D01 / Geotechnical Planning Review Report

Proposed Development of La Casetta DD399 Lot 453 Ting Kau

Comments from Geotechnical Engineering Office, Civil Engineering and Development Department (2024.07.18)

Proposed Development of La Casetta DD399 Lot 453 Ting Kau
 Comments from Water Supplies Department (2024.07.18)

Proposed Development of La Casetta DD399 Lot 453 Ting Kau
Figure 1 - Location Plan

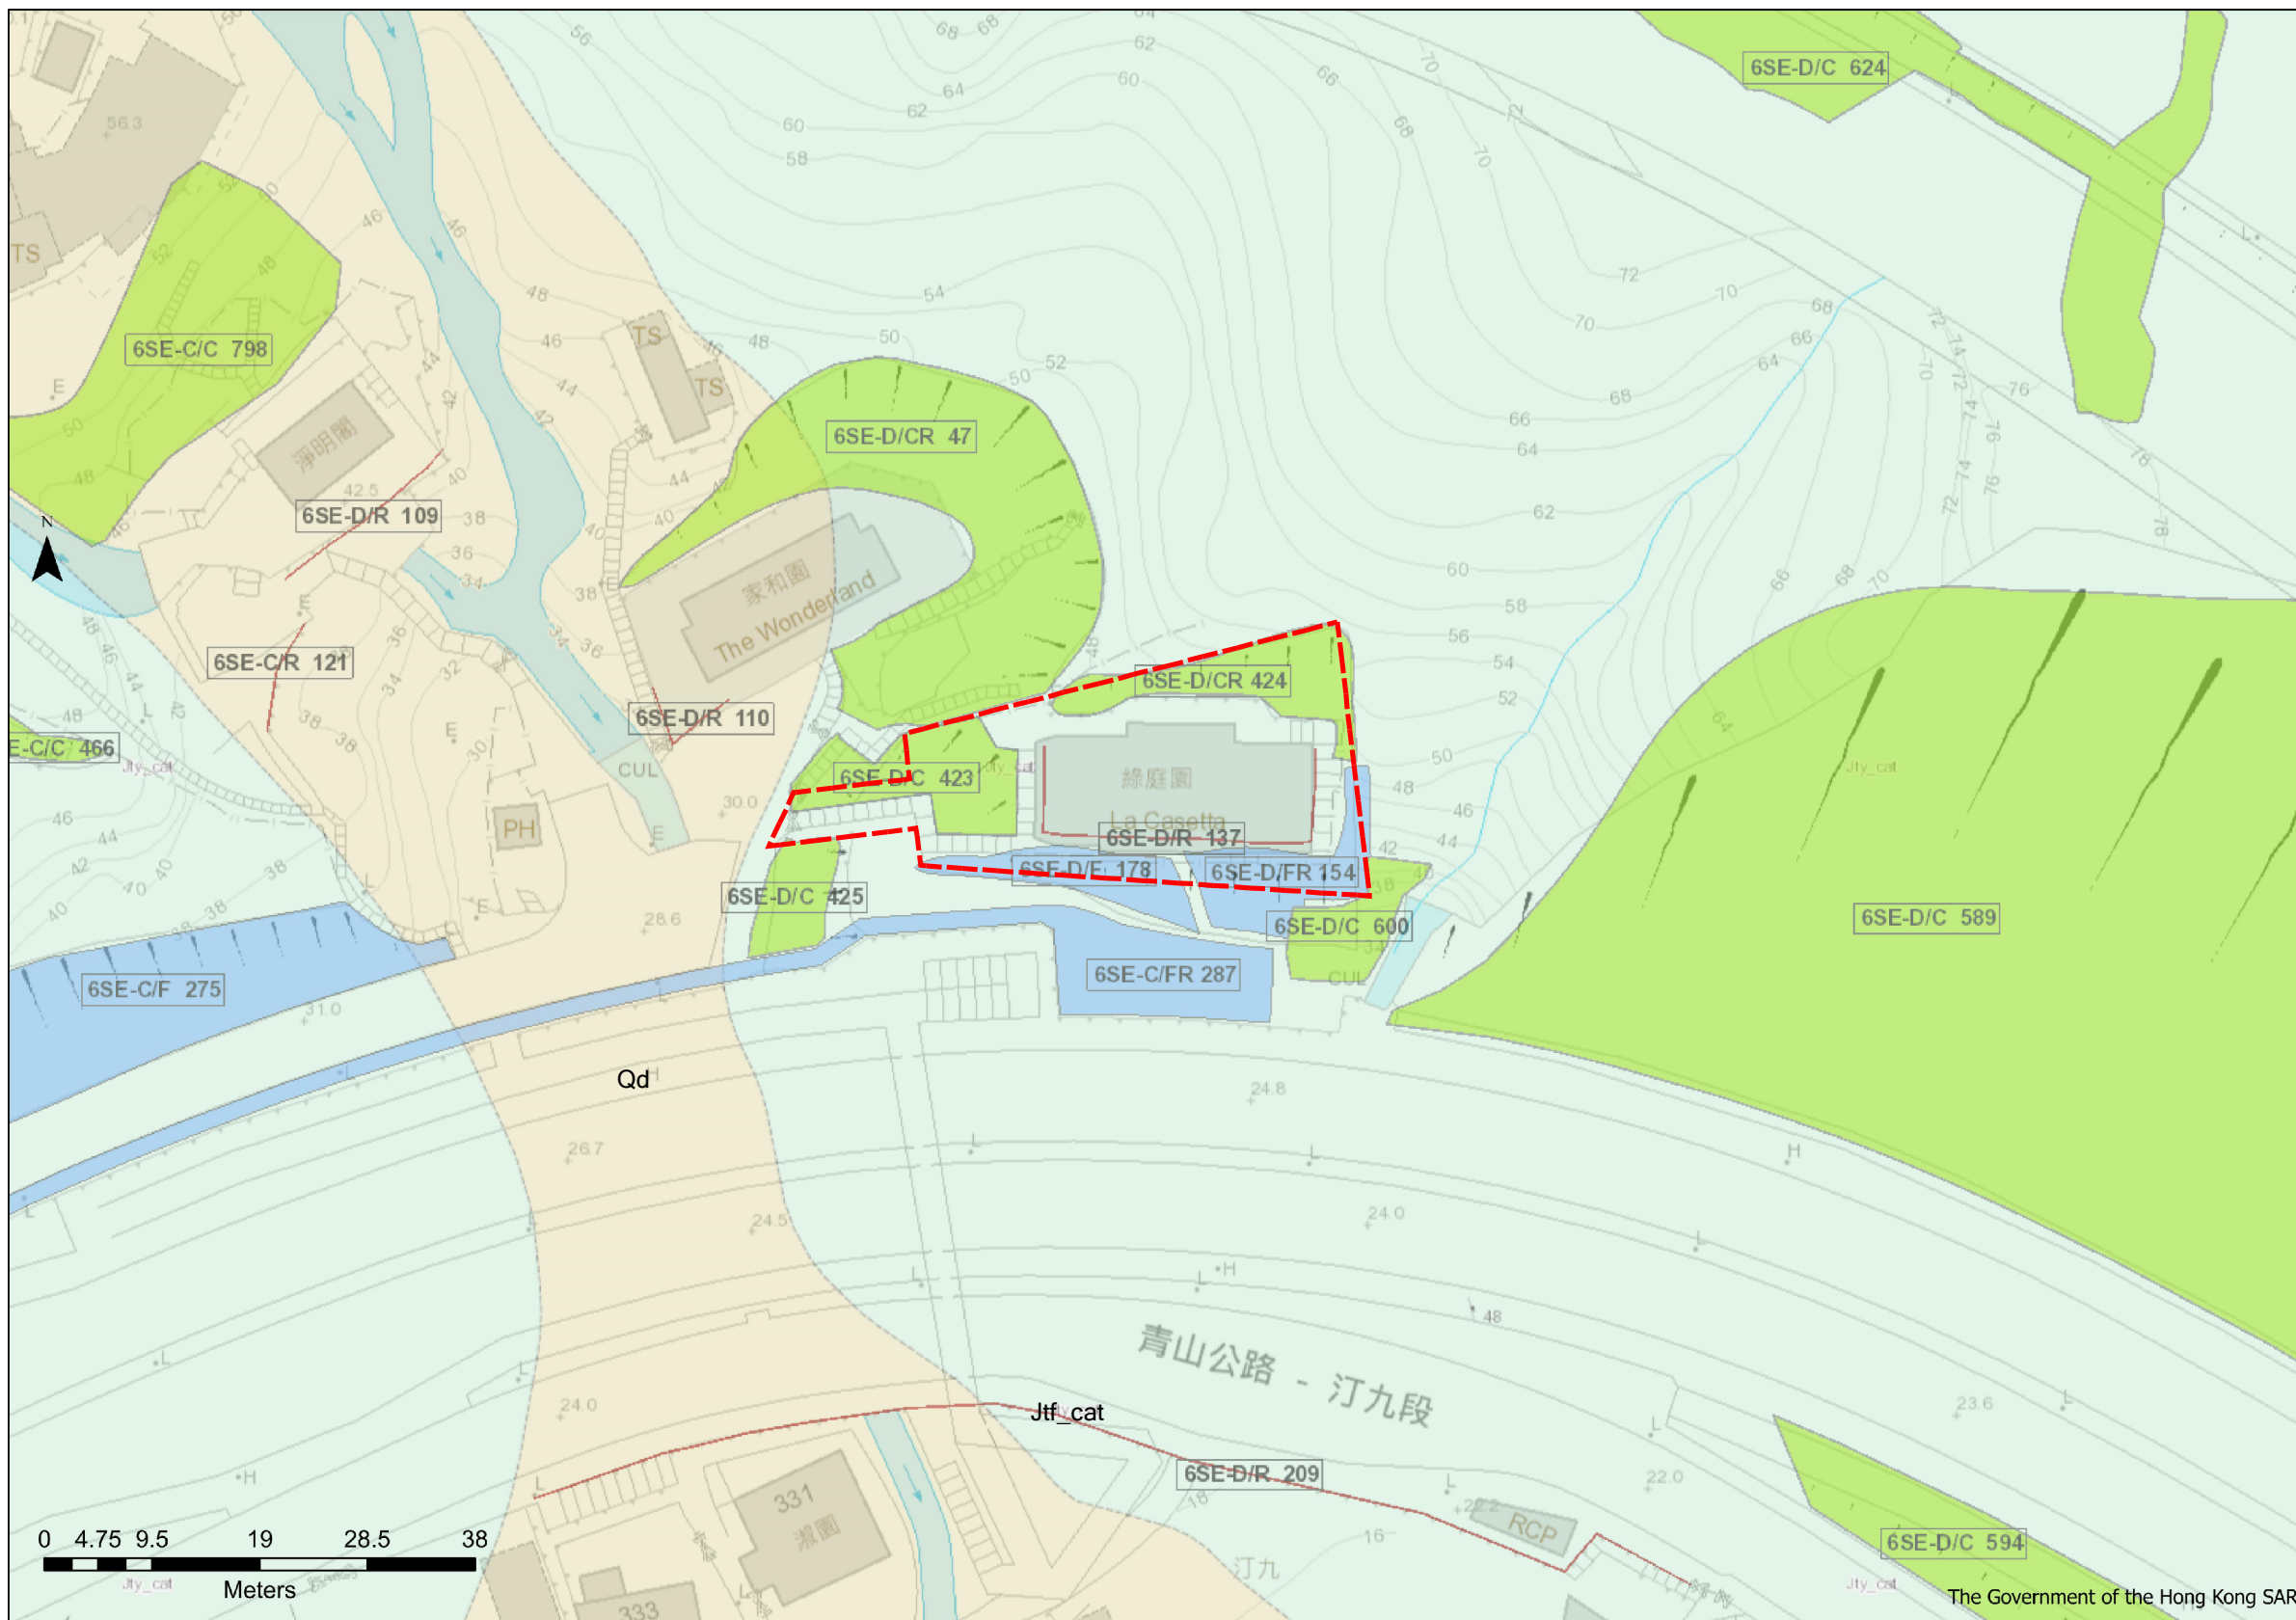
2	<p>Figure 1 – Location Plan – “6SE-D/CR57” should read “6SE-D/CR47”. Please ask the Consultants to revise the typo.</p>	<p>Noted. The typo in Figure 1 is revised.</p>

MASTER LAYOUT PLAN
 MLP-01 SCALE: 1:200 (A3)

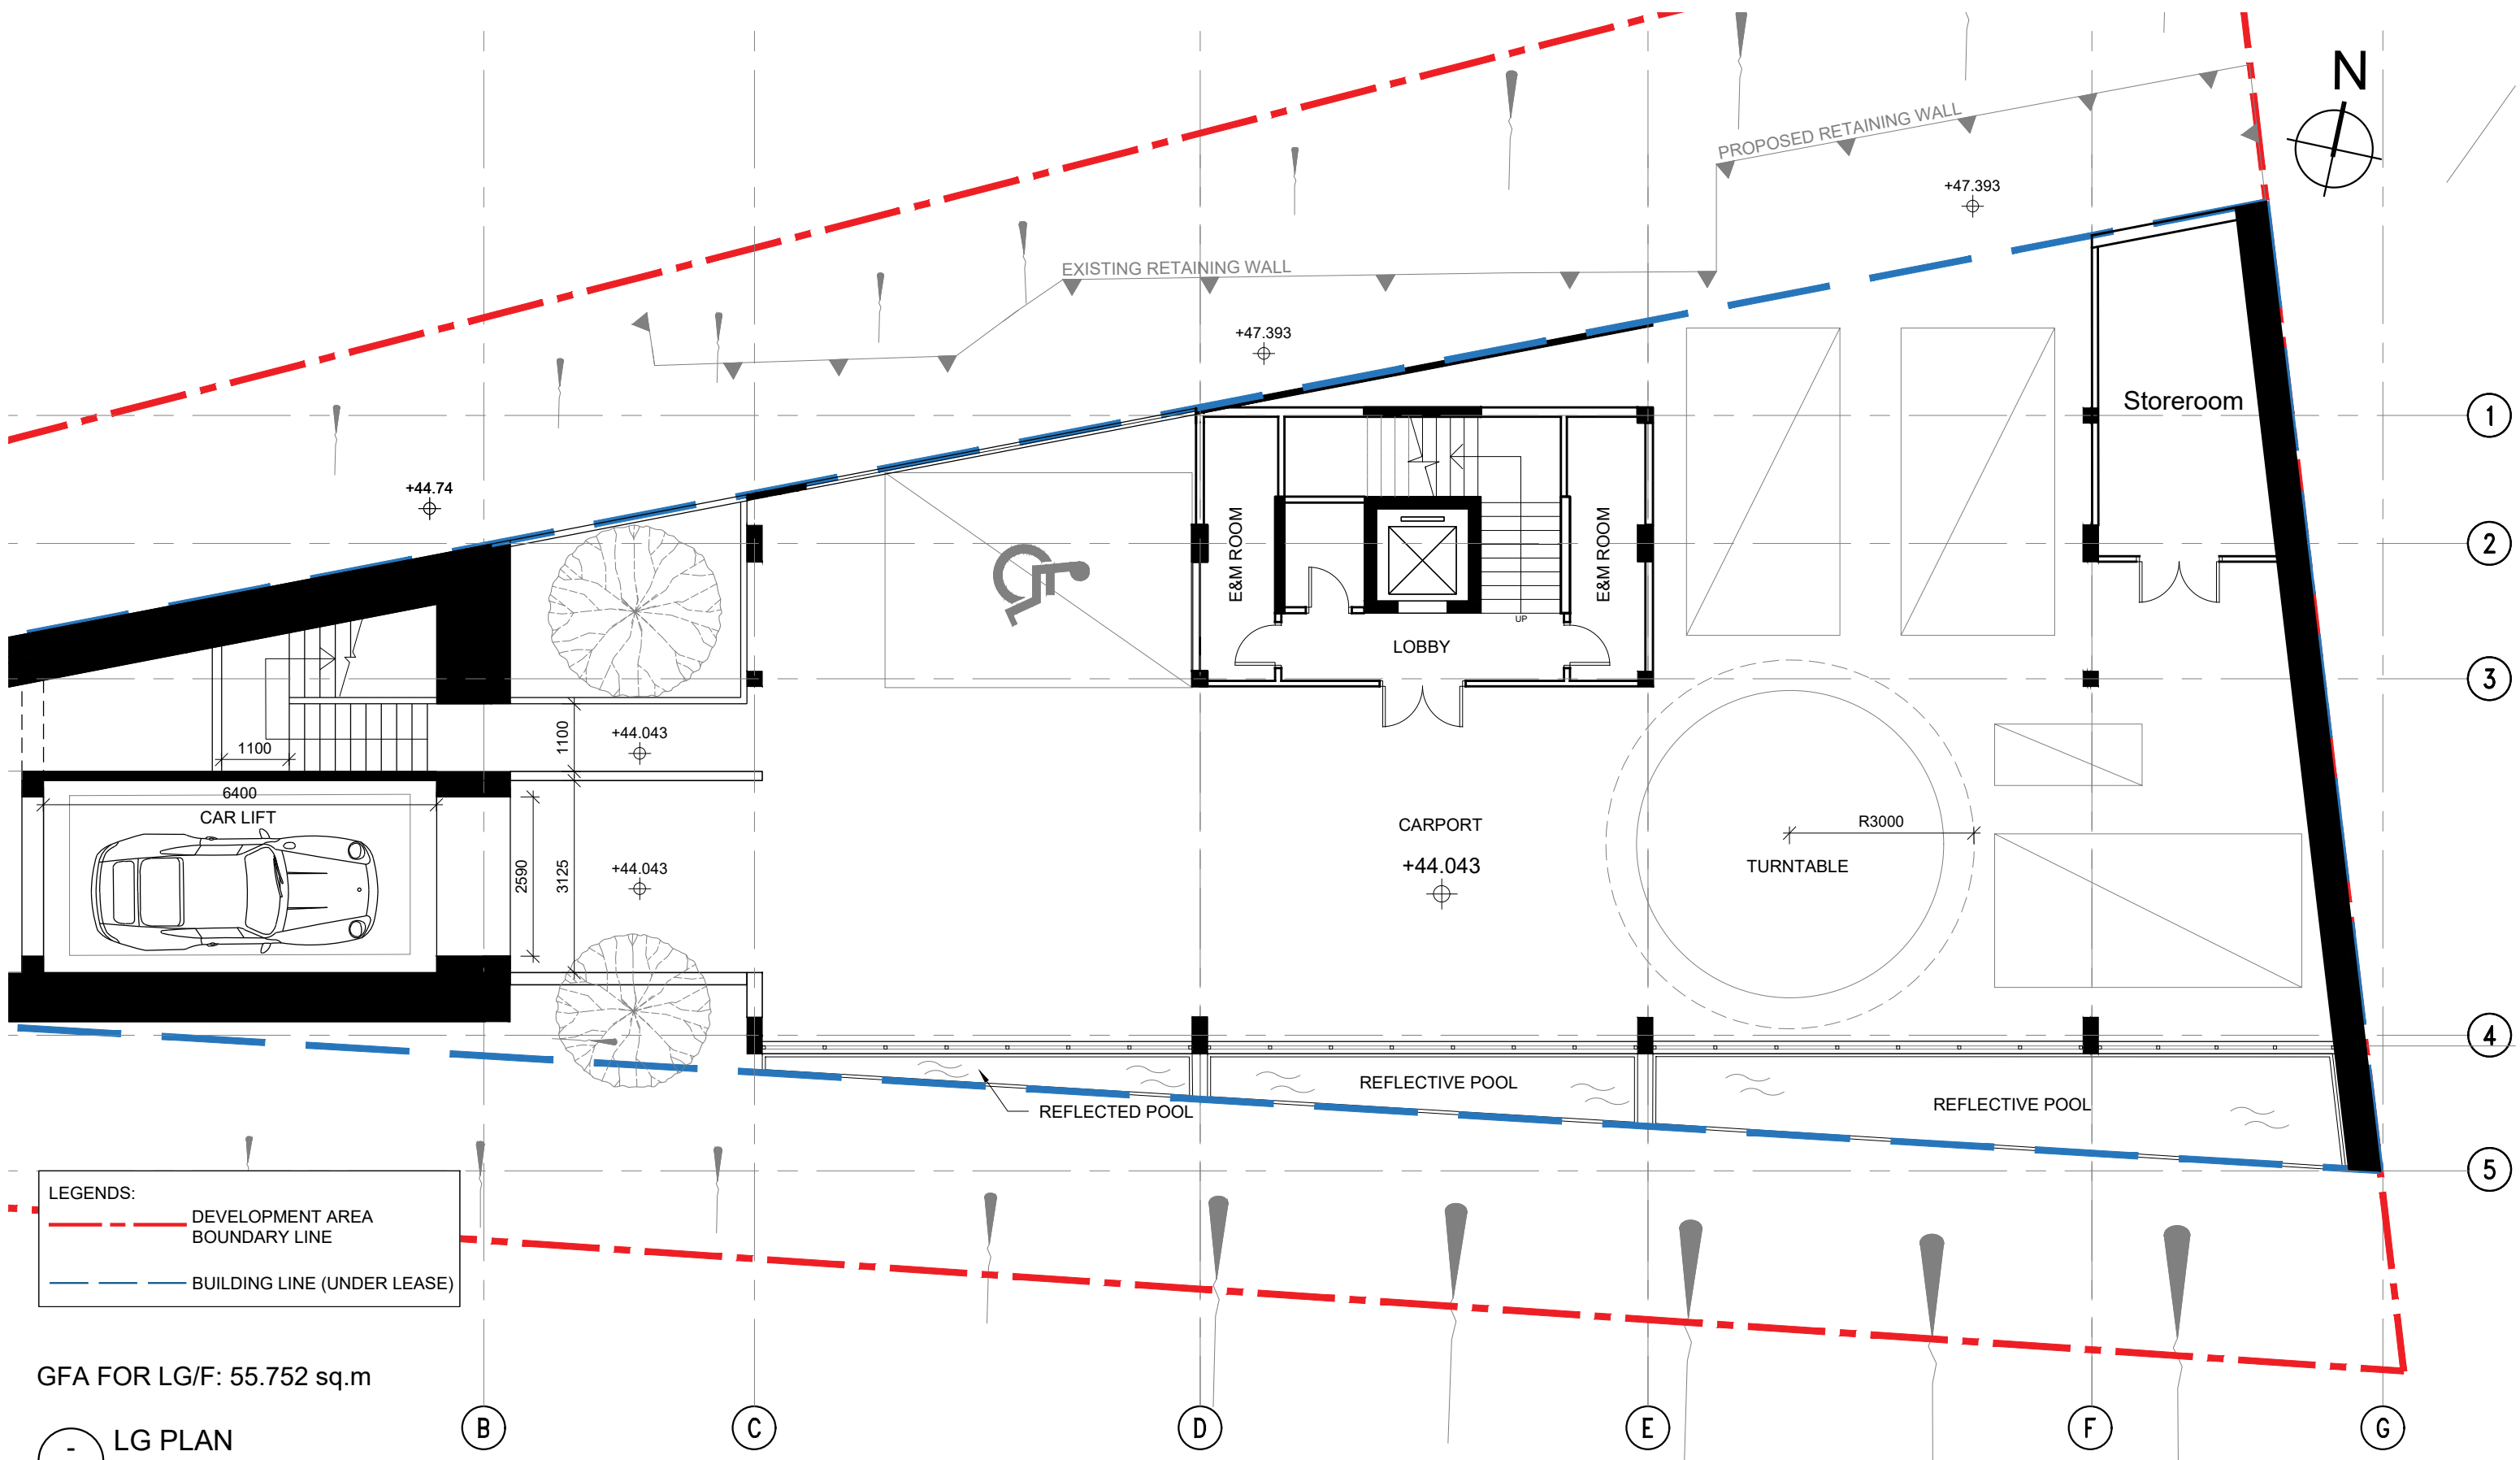
Item	GEO's Comments	SMEC Responses
1	<p>Section 5.2.3 and Appendix A – It is noted from the location plan that part of Feature no. 6SE-D/F178 falls within the site boundary. Please ask the Consultants to review and clarify if the feature would encroach onto the footprint of the proposed buildings and if any modification works of the slope feature will be required. In addition, Appendix A should be updated to clearly show the location of the man-made features and details of the proposed development including any site formation.</p>	<p>Noted. The location of the man-made features and details of the proposed development are now presented in the schematic layout plan in Appendix C.</p> <p>Although part of Feature no. 6SE-D/F178 falls within the site boundary, the slope feature is located outside the building boundary. It is considered that the proposed development will not affect the feature. Nevertheless, modification or upgrading works of the feature might be required if the existing stability of the feature is found to be below the current geotechnical standard in detailed design stage.</p>

PART COPY OF FRESH WATER MAINS RECORD PLAN(S)

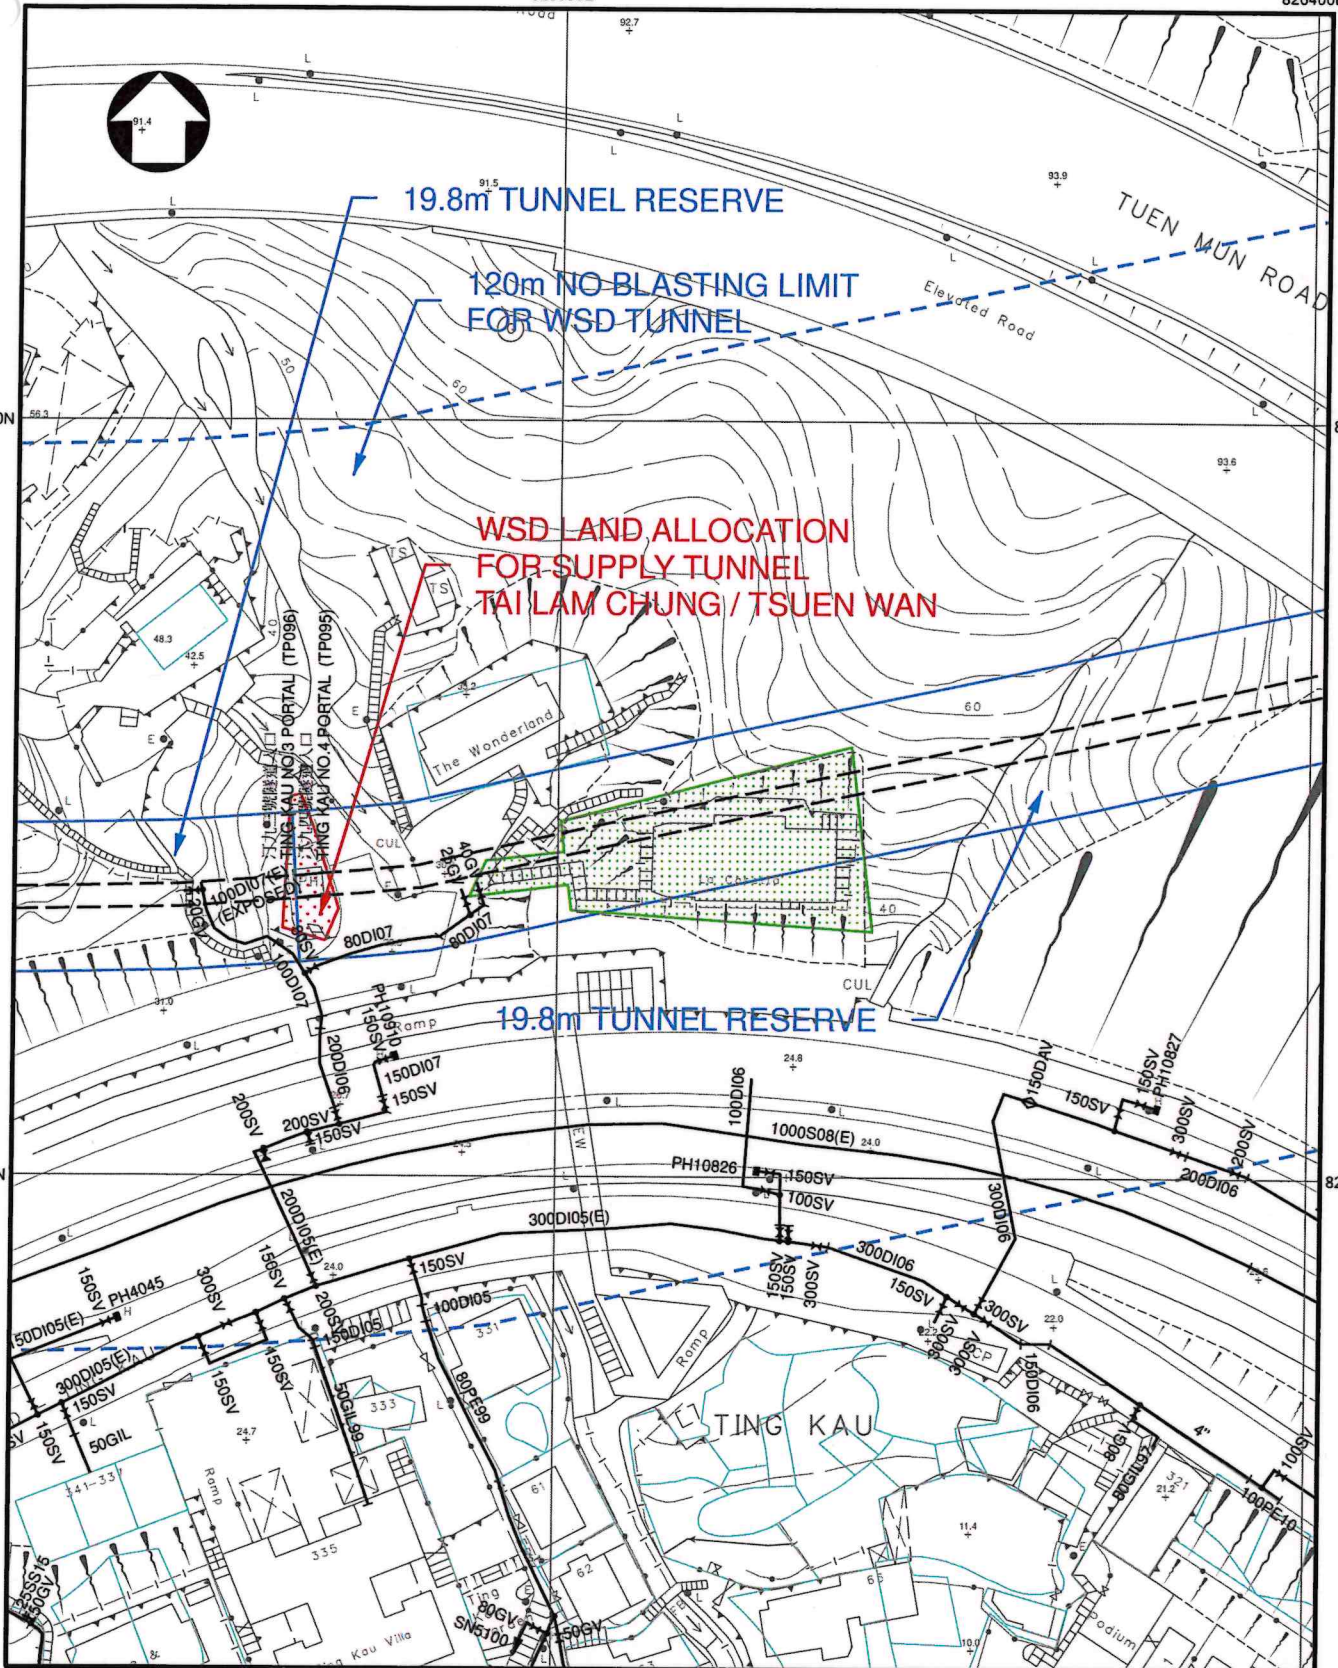
Item	WSD's Comments	SMEC Responses
1	<p>No excavation, drilling or filling shall be carried out within 60 metres on plan (attached) from the centre line of the WSD Tunnel as shown on the plan except:</p> <p>(a) Minor excavation works for lamp post pits, trial pits, trenches for utility laying etc. with depth of excavation less than 2 metres or with minimum clearance of 20 metres on plan from the tunnel;</p> <p>(b) Drilling that involves no blasting or heavy machinery inducing excessive vibration and with a minimum clearance of 20 metres on plan from the tunnel; and</p> <p>(c) Filling works inducing additional vertical and horizontal pressure of not more than 5% of the total overburden pressure on any tunnel.</p>	<p>Based on the as-built drawings, the level of the existing WSD tunnel near the proposed development is approximately +19.8mPD.</p> <p>Although the proposed development will involve excavation and drilling works within the tunnel reserve zone, in order to avoid any adverse impact on the WSD Tunnel, the geotechnical scheme is revised as shown in Appendix D. With the following considerations, the potential impact of the proposed development on the existing WSD Tunnel is relatively insignificant.</p> <p>a. The proposed development, which includes the construction of a car lift by excavating the existing ground, and the re-development of the residential building with same no. of levels, will not introduce additional loadings or increase the hydrostatic pressure to the WSD Tunnel.</p> <p>b. There is sufficient clearance (~7.7m) of more than two times the diameter of the tunnel, which is only 2 m in diameter, between the proposed structure (i.e., the proposed footing structure at +27.5 mPD) and the tunnel crown (at +19.8 mPD).</p> <p>c. Based on the available GI records, the rockhead level above the tunnel is relatively high, approximately +30mPD at the location of the</p>

<p>proposed car lift. Hence, there is a significant rock cover above the tunnel, which is about 7.7 m. It is therefore considered that the proposed development will induce minimal impact to the tunnel.</p> <p>d. The proposed construction method, without blasting or percussive piling method, will induce minimal vibration to the adjacent ground as well as the tunnel, which is located at about 11.2 m below ground.</p> <p>Practice Note “DSD PN No. 2/2017 - Assessment on the Effects of Construction Activities on Drainage and Sewage Tunnels and their Associated Structures”, which is extracted in the following page, has been identified as an additional reference. It is considered that the proposed geotechnical works generally fulfil the requirements specified in the Practice Note.</p> <p>On the other hand, it shall be noted that after the WSD tunnel was completed back in 1950s, there were precedents that nearby developments were approved and constructed, for instance, the original development of La Casetta (1979), the Wonderland (1964), and the Lido Green (1976).</p> <p>Nevertheless, detailed impact assessment on the tunnel shall be carried out in the detailed design stage and construction stage based on more comprehensive geological information and geotechnical data. In addition, instrumentation monitoring shall be carried out during the construction stage to ensure the works would not affect the tunnel.</p>
